SUBDIVISION REVIEW SHEET**CASE NO.:** C8-2023-0149.1A**COMMISSION DATE:** September 5, 2023**SUBDIVISION NAME:** Eastside Commerce Subdivision**ADDRESS:** 1312 Dalton Ln**APPLICANT:** David M. Blackbird (SRPF C/Dalton Lane, LP)**AGENT:** Thomas Lombardi, Jr. (Kimley-Horn)**ZONING:** CH-CO, CS-CO, LI**NEIGHBORHOOD PLAN:** N/A**AREA:** 59.859 acres**LOTS:** 12**COUNTY:** Travis**DISTRICT:** 3**WATERSHED:** Carson Creek**JURISDICTION:** Full Purpose**SIDEWALKS:** Sidewalks will be constructed along Dalton Lane and SH 71.**DEPARTMENT COMMENTS:**

FINAL PLAT
EASTSIDE COMMERCE
SUBDIVISION

CITY OF AUSTIN –DEVELOPMENT SERVICES DEPARTMENT
SUBDIVISION APPLICATION – MASTER COMMENT REPORT

PROJECT NAME: Eastside Commerce Subdivision
LOCATION: 1312 DALTON LN

SCALE	DRAWN BY	CHECKED BY	DATE	PROJECT NO.	SHEET NO.
1" = 100'	TJR	MMII	6/15/2023	068213106	2 OF 4

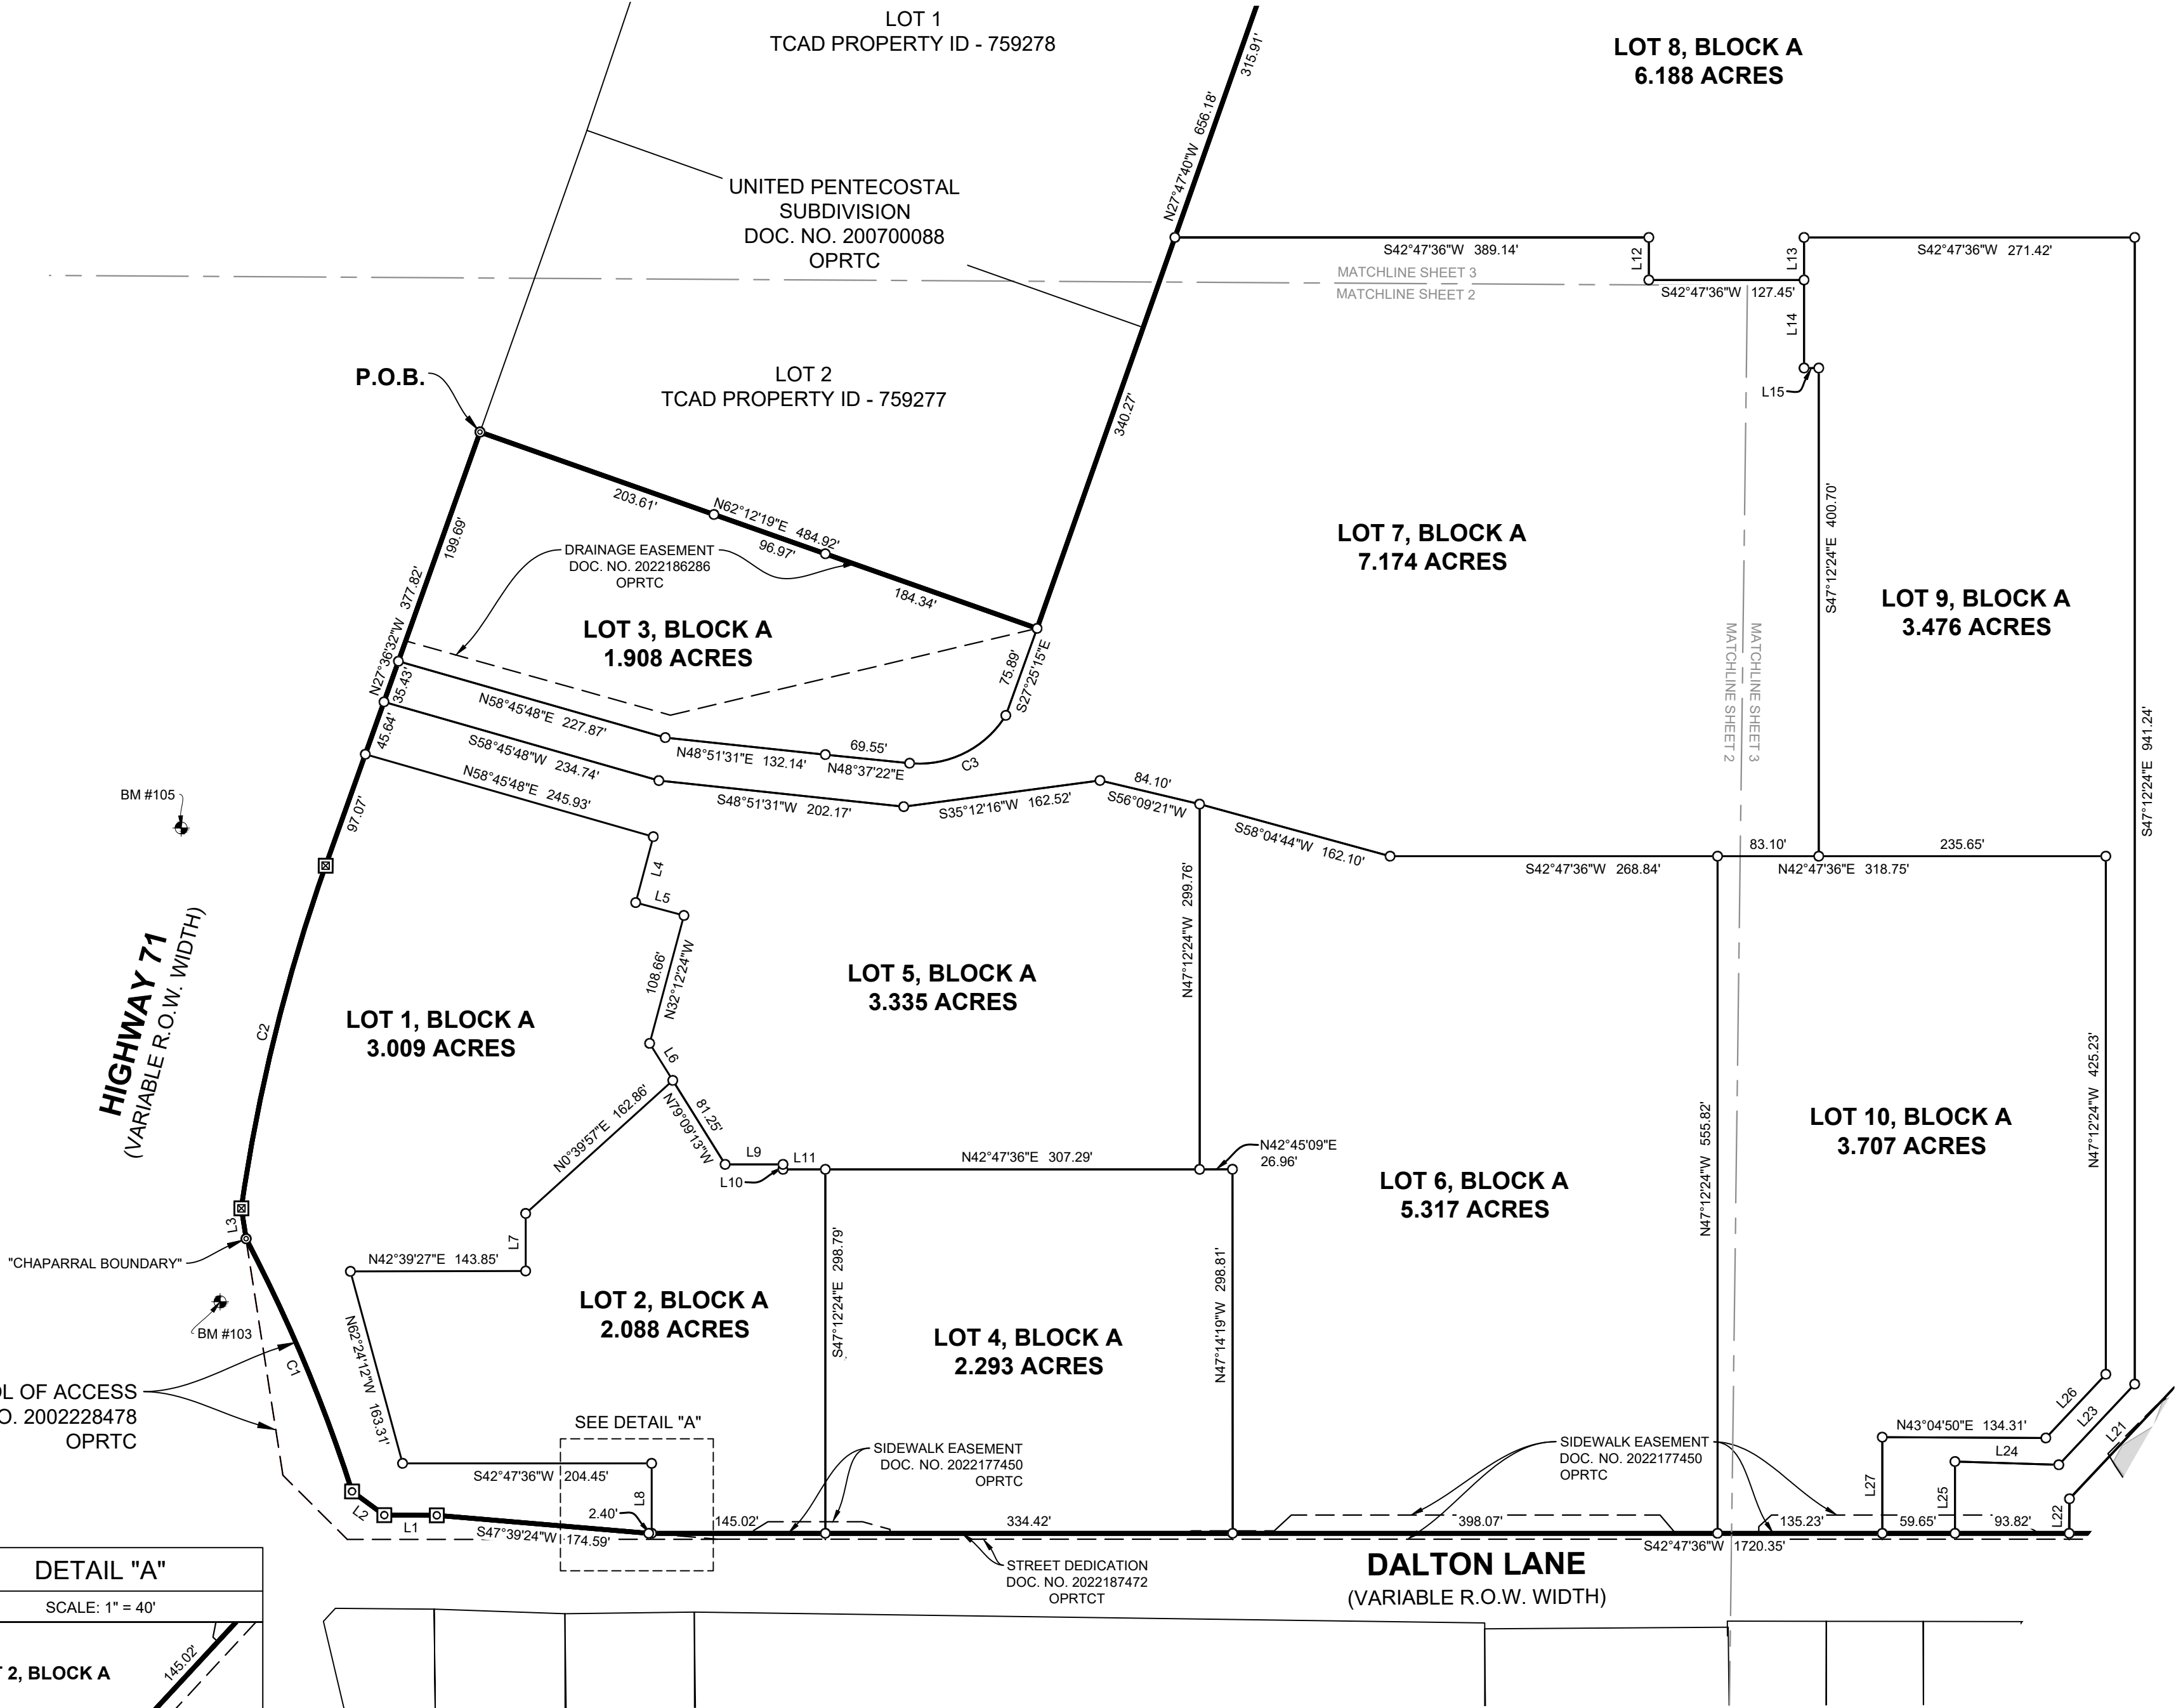
Fifteen-foot electric distribution, electric telecommunications, and electric fiber easement is required adjacent to Dalton Ln R.O.W. Show the easement on the face of the plat.
- EL 2. [LDC § 25-4-132 - EASEMENTS AND ALLEYS.](#)
(A) Easements for public utilities and drainage ways shall be retained in all subdivisions in the widths and locations determined necessary by the director. All easements shall be dedicated to public use for the named purpose and shall be aligned to minimize construction and future maintenance costs.
Source: § 13-2-421; Ord. 990225-70; Ord. 010607-8; Ord. 031211-11; Ord. 20131017-046

AD2: Please update label for **E SH 71** the directional E must be included

AD4: Please update label for **S US 183 HWY** the directional S must be included

- ATD 3. The ASMP requires 84 feet of right-of-way for Dalton Lane. Dedicate 42 feet of right-of-way from the existing centerline in accordance with the ASMP (LDC 25-6-55).

- ATD 6. No direct access from a lot to a major roadway is permitted on a subdivision plat if the lot has less than 200 feet of frontage on the roadway and alternative access is available. LDC 25-6-381(B). Either prohibit access to Highway 71 from Lots 5 and 7 or provide a joint use access easement to Highway 71 from Lots 3, 5 and 7 and provide a plat note.

- ATD 7. Joint access may be required at the time of subdivision approval for abutting lots on a major roadway or Hill Country Roadway which have insufficient frontage to allow a driveway approach for each lot in accordance with the requirements of the TCM. LDC 25-6-381(E). Provide joint use access to Highway 71 from Lots 3, 5, and 7. A plat note will be required once the JUAE is established.

- ATD 8. The number of driveways on an arterial street should be minimized in order to reduce the number of conflict points and facilitate traffic flow. TCM, 5.3.1.M. Staff recommends providing joint use access to Dalton Lane from Lot 1.

FP 3: The applicant is required to contain the limits of the FEMA and City of Austin Regulatory floodplain within a drainage easement per LDC 25-7-152 and/or LDC 30-4-152. Please provide documentation demonstrating this or provide requisite easement. Comment to remain open until easement has been recorded.

HG1_U0 Clearly show the boundaries of all Critical Environmental Features and clearly label the feature(s): "CRITICAL ENVIRONMENTAL FEATURE" on all sheets that it exists.

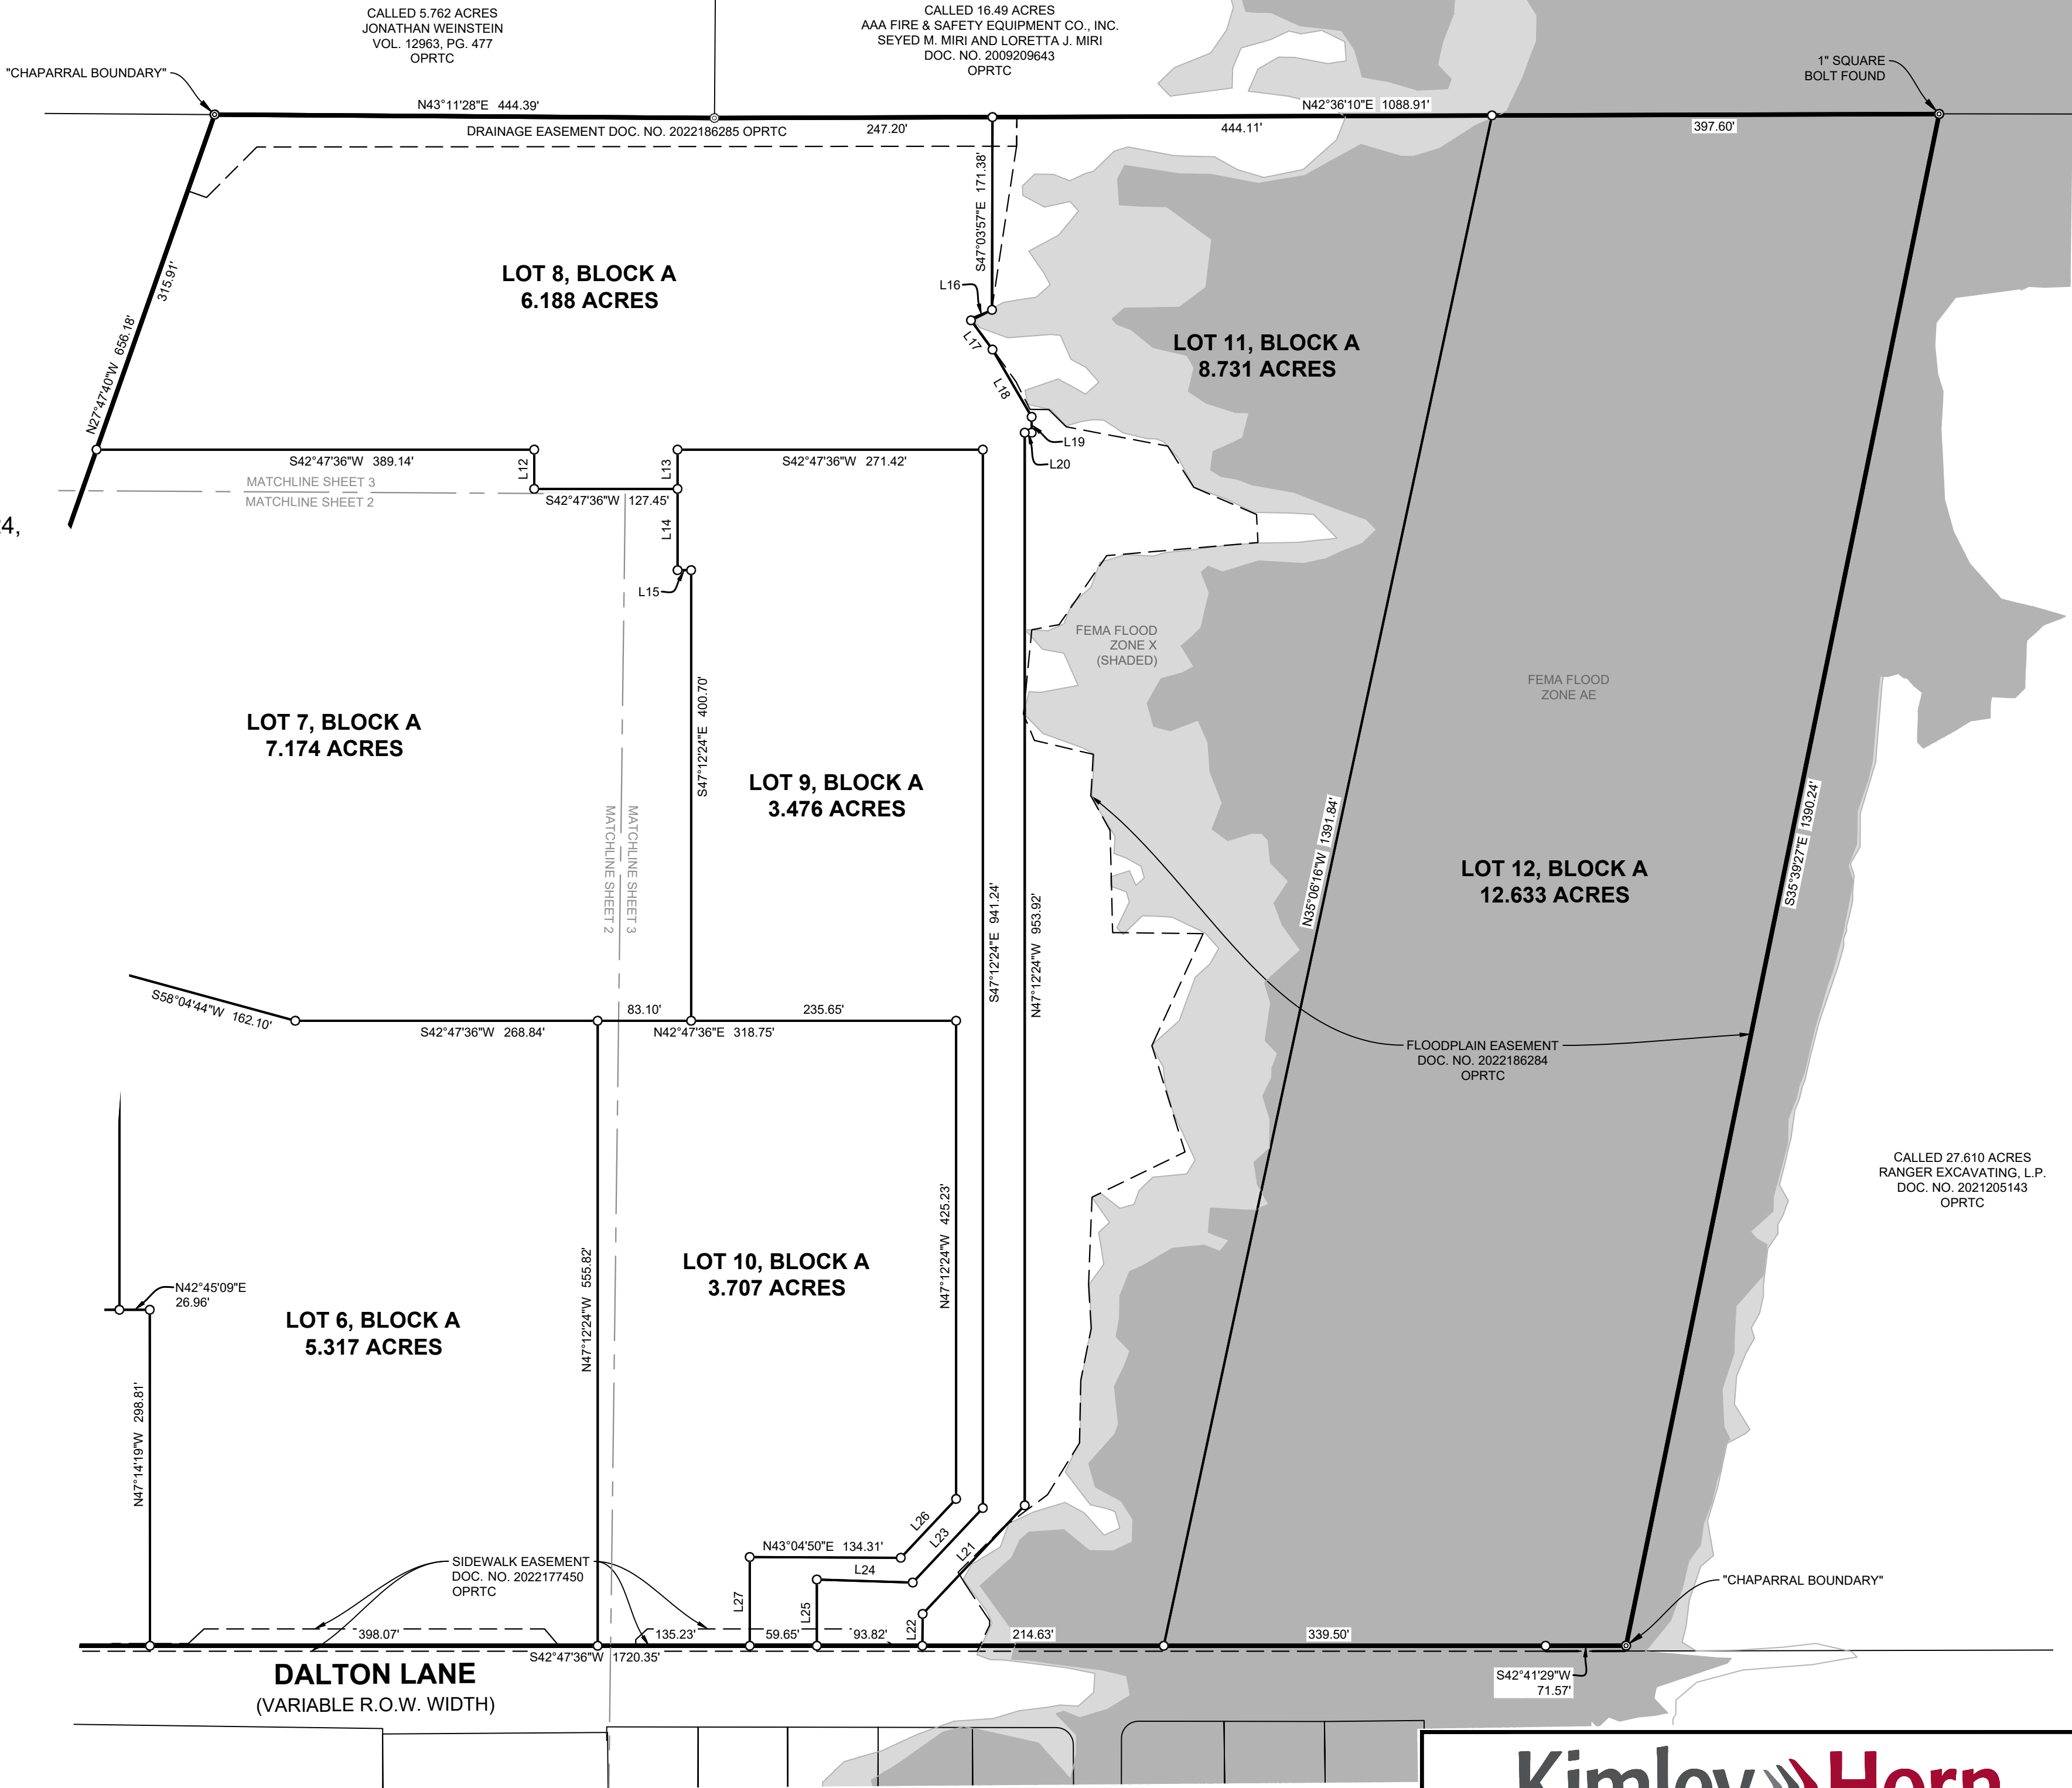
- AW3. Per Utility Criteria Manual Section 2, §25-4, and the Uniform Plumbing Code:
Remove note 2. There are no public water or wastewater easements within the boundaries of the plat. No public water and/or wastewater easements will be approved internal to this site. All lots shall obtain water and wastewater service from the ROW frontage.

- AW2. Per Utility Criteria Manual Section 2, §25-4, and the Uniform Plumbing Code:
Replace note 22 with the following note.
NO LOT SHALL BE OCCUPIED UNTIL THE STRUCTURE IS CONNECTED TO THE CITY OF AUSTIN WATER AND WASTEWATER UTILITY SYSTEM.

- ATD 4. Please pay the ATD Final Plat review fee in AMANDA.
- ATD 5. Please show the dotted lines along Dalton Lane and Highway 71 for the sidewalk per the legend and add Highway 71 to plat note #10.

- SR 5. Please revise the following note on sheet 4 which is required to be placed on the plat by the
Travis County Clerk's office: 25-1-83; 30-1-113: "This subdivision plat is located within the full
purpose jurisdiction of the City of Austin on this the ____ day of _____
20__."
- SR 6. Since this project lies within the City of Austin full purpose jurisdiction, remove the following from
sheet 4 (25-1-83):

- SR 7. Remove the following from sheet 4 (25-1-83):
CITY OF AUSTIN §
CERTIFICATE OF APPROVAL §
- SR 8. Revise the notary signature block on sheet 4 as follows: 25-1-83 or 30-1-113
State of Texas §
County of Travis §
